**RE: North Houston Highway Improvement Project [NHHIP] – CSJ 0912-00-146
– Addendum 1 to Visual Impact Assessment Report / Draft Noise Technical
Report**

Following are the Houston Parks Board's [HPB] comments regarding TxDOT's recent release of the Visual Impact Assessment and Draft Noise Technical Report of the NHHIP. These comments support the Make I-45 Better Coalition's further comments regarding these technical reports and the accompanying Noise and Hazardous Materials report.

White Oak Bayou Greenway

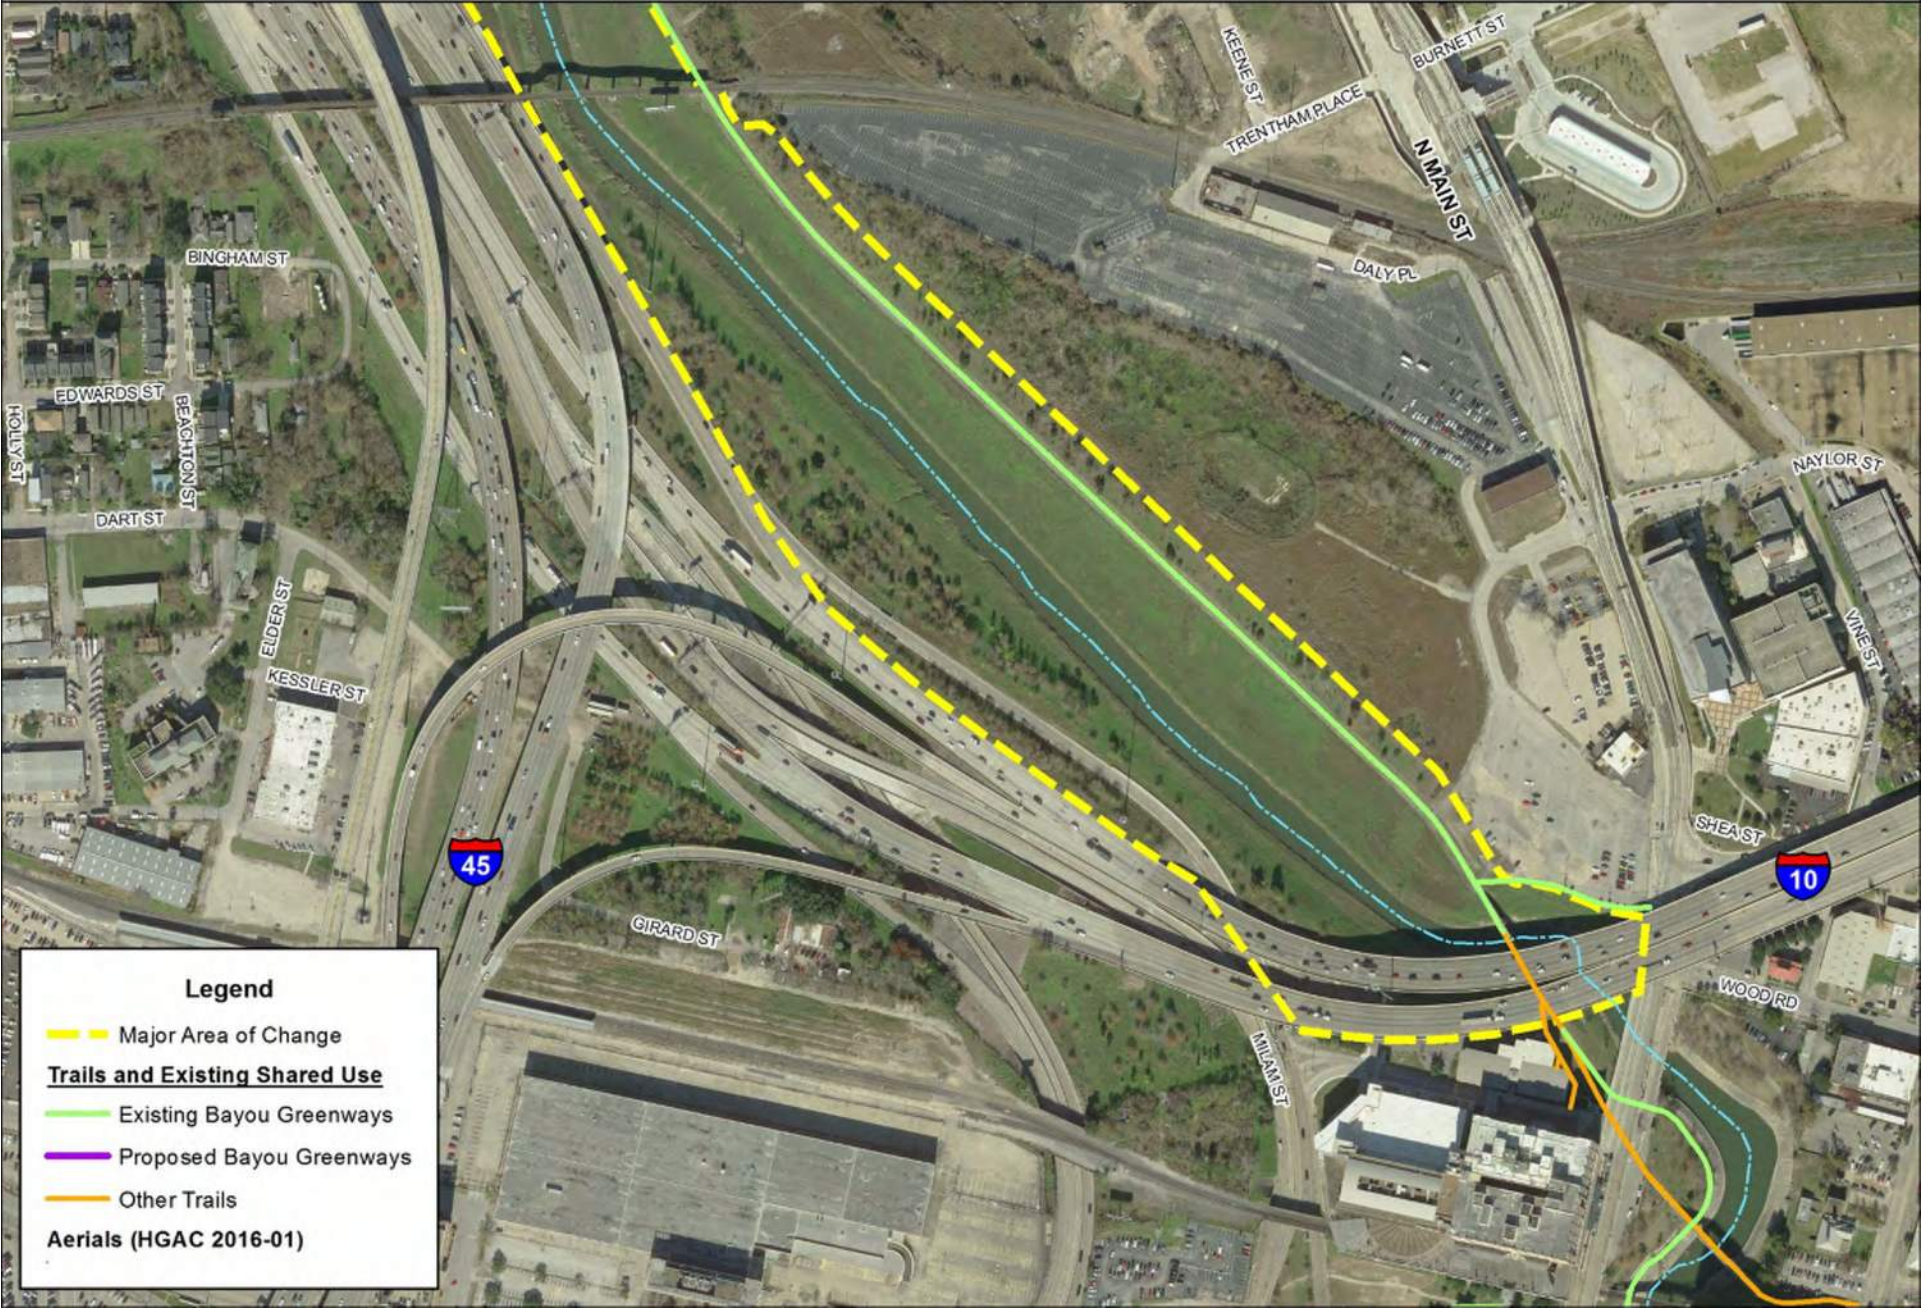
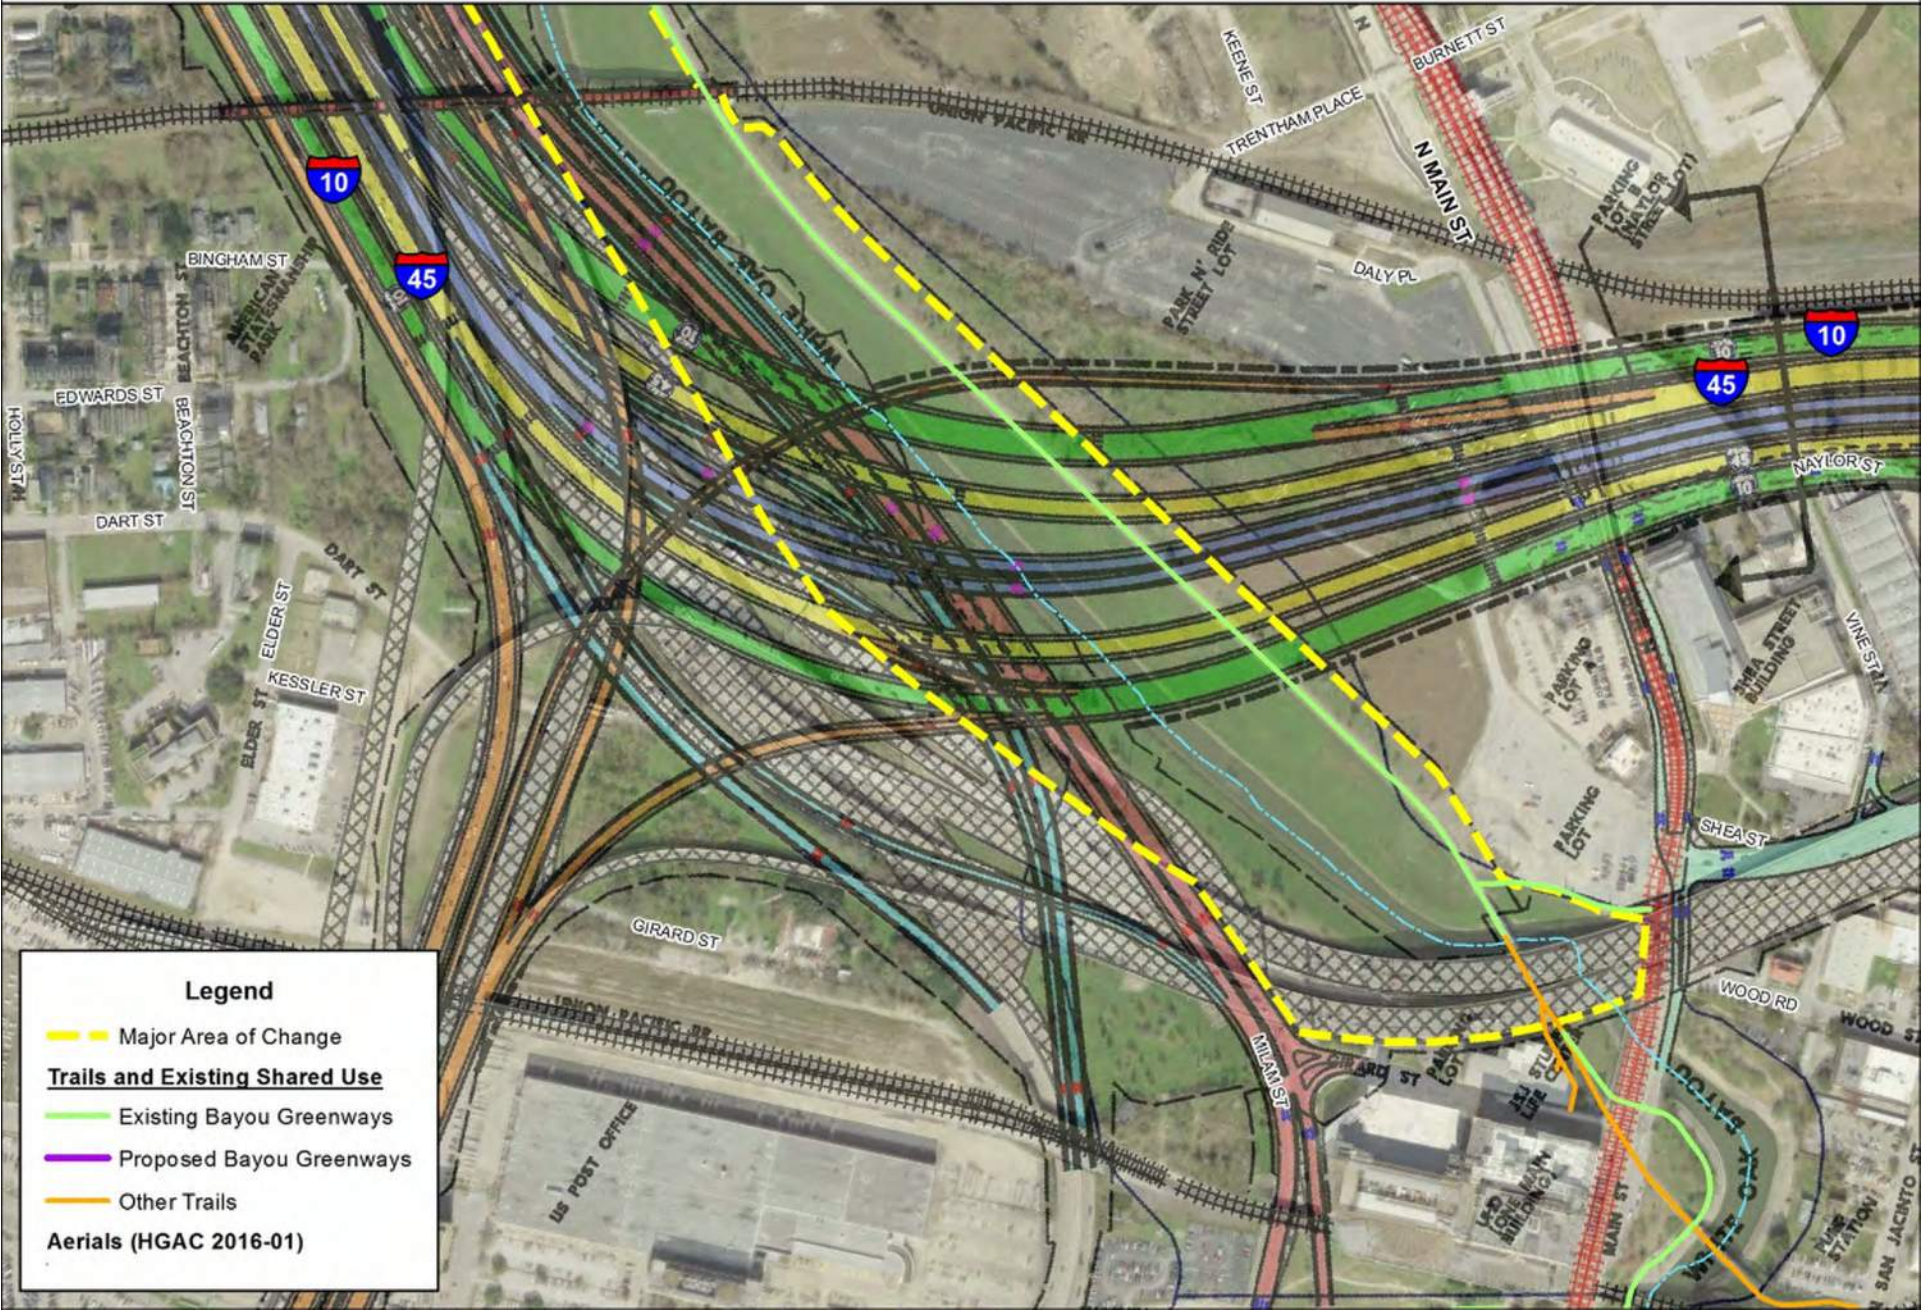
While the project eliminates the I-10 overpass adjacent to UHD, that present alignment is massed with the UHD buildings and Main Street minimizing the overall impact. However, The NHHIP reroutes 20 lanes of highway with some 7 new overpasses directly over the presently open parkland upstream of UHD. That impact is far more significant both qualitatively and in its overall scope and scale than what would be removed. HPB had previously noted a net impact to

18 acres of open space. The report's Figure 4 illustrates the new overpasses as a distant image, unrelated to the parkland it impacts. "Miscellaneous aesthetic improvements" are offered as mitigation.

HPB had commissioned its own visual impact analysis of NHHIP at White Oak Bayou Greenway Park (Exhibit A). We have shown it to a number of community groups over the past year. At each showing it elicits strong reactions of surprised shock. Again, the visual impact analysis should have been included in the DEIS so that the public could understand the significant impact during the main comment period.

HOUSTON PARKS BOARD UPDATE TO TxDOT FIGURE 6

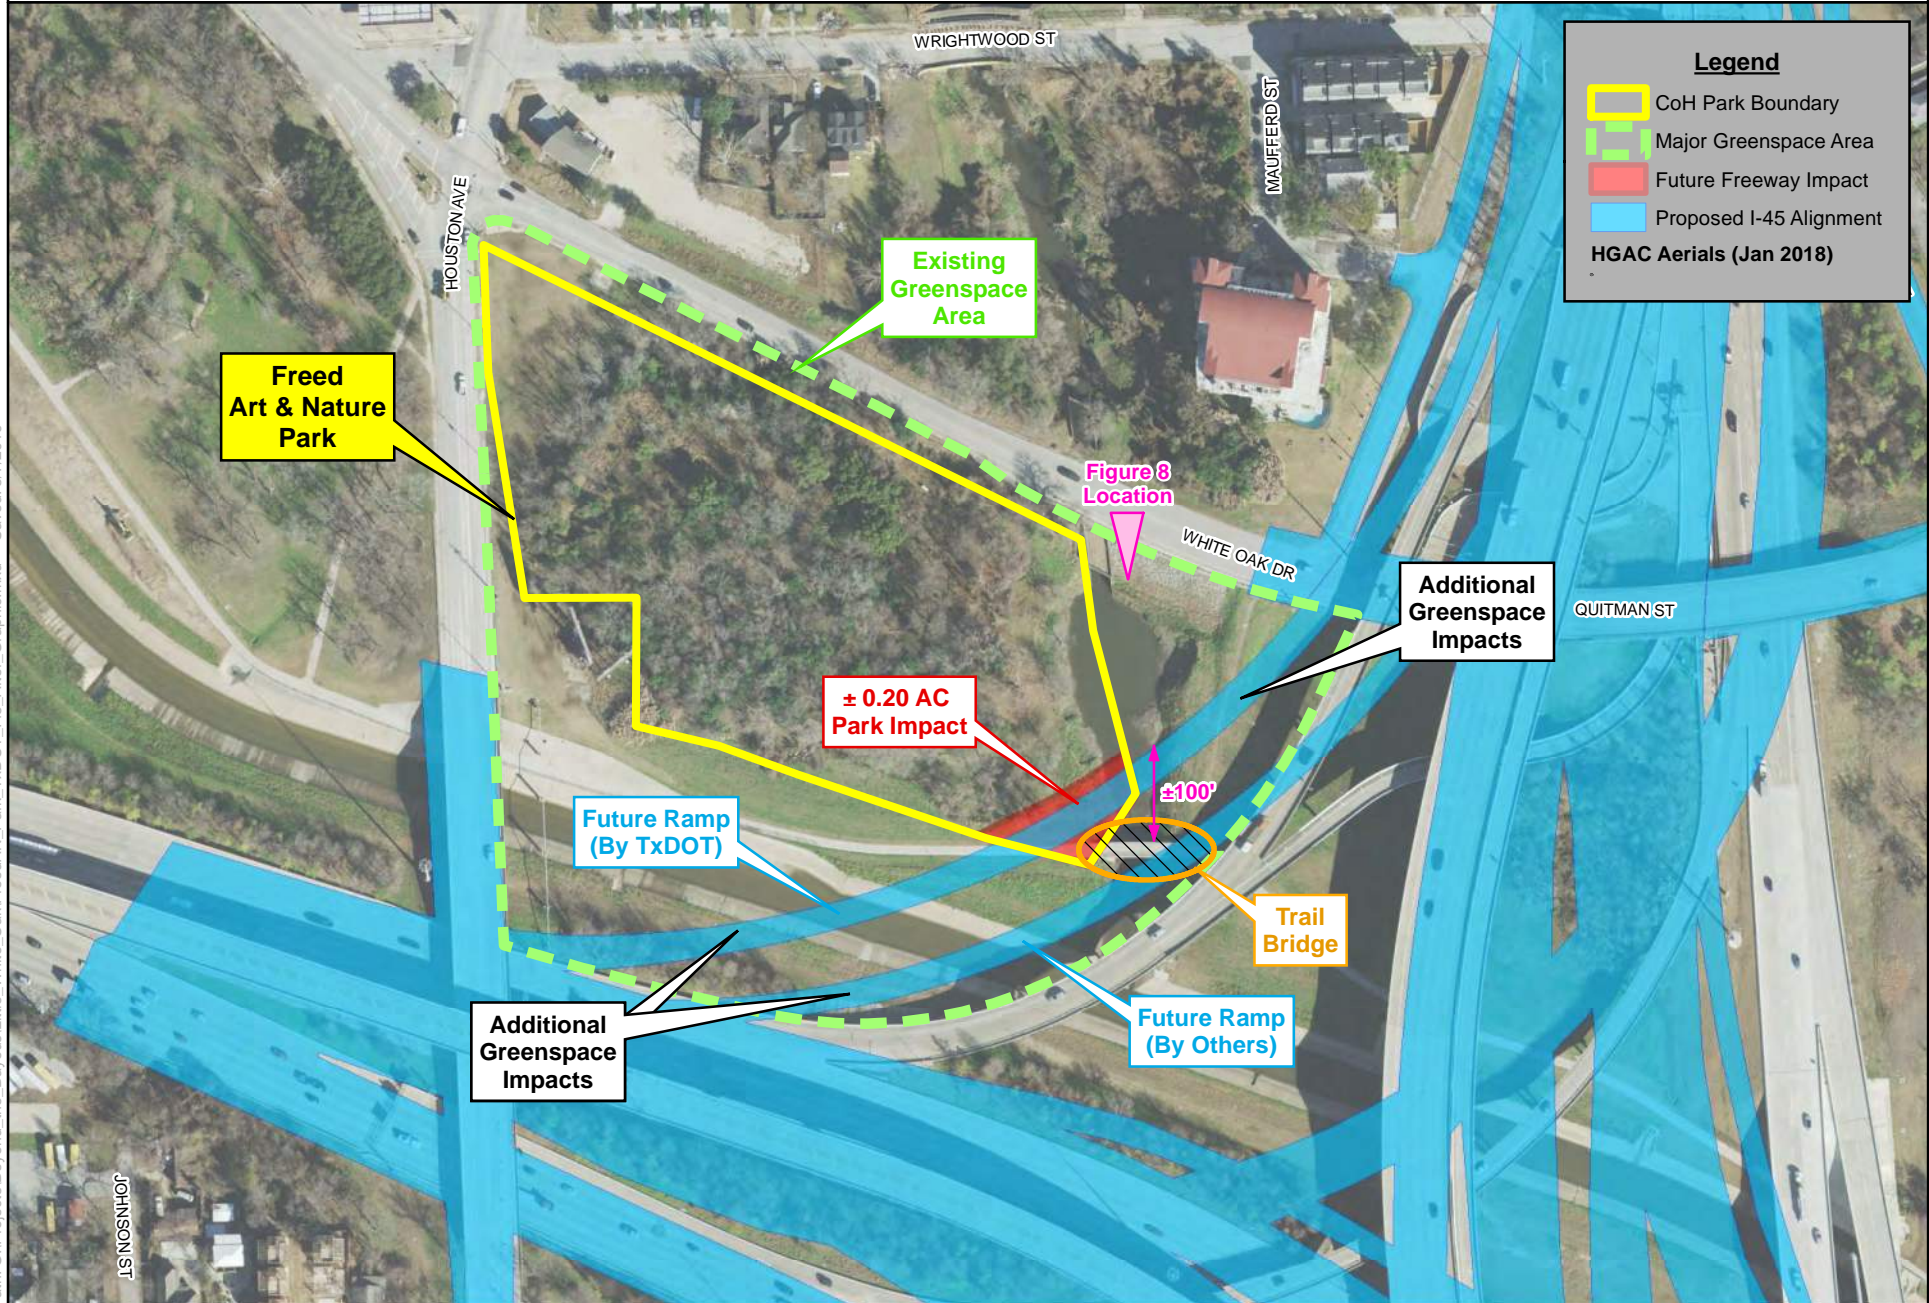
The report states that, “The existing visual quality on the Heights Bike Trail at White Oak Bayou is moderate, as no large elevated transportation facilities obstruct the view of Downtown (figure 5); however, the bayou has moderate to moderately low quality visual appeal because there are no improvements to the bayou or concrete drainage system to enhance the quality of landscaping in the area.” However, since the bayou has grass and wild flowers to its edge in this area (not concrete), and there is a line of trees that blocks the view of the current alignment of I-10, we contend that the current view of Downtown from the trail (Figure 5) is high visual quality. As it pushes a combined I-10 and I-45 against the very edge of White Oak Bayou’s southern shoreline, the NHHIP project obliterates the tree line that currently blocks views of present I-10 looking toward downtown. Along with the new elevated overpasses, this changes the view quality from high to low. The report’s Figures 5 and 6 do show that impact even as it distracts the analysis with images of park benches and canoes. Nor are the before and after views comparable. The canoes and water shown in Figure 6 would not be visible without realigning the bayou, which to our understanding is not planned and therefore should not be shown in the rendering.
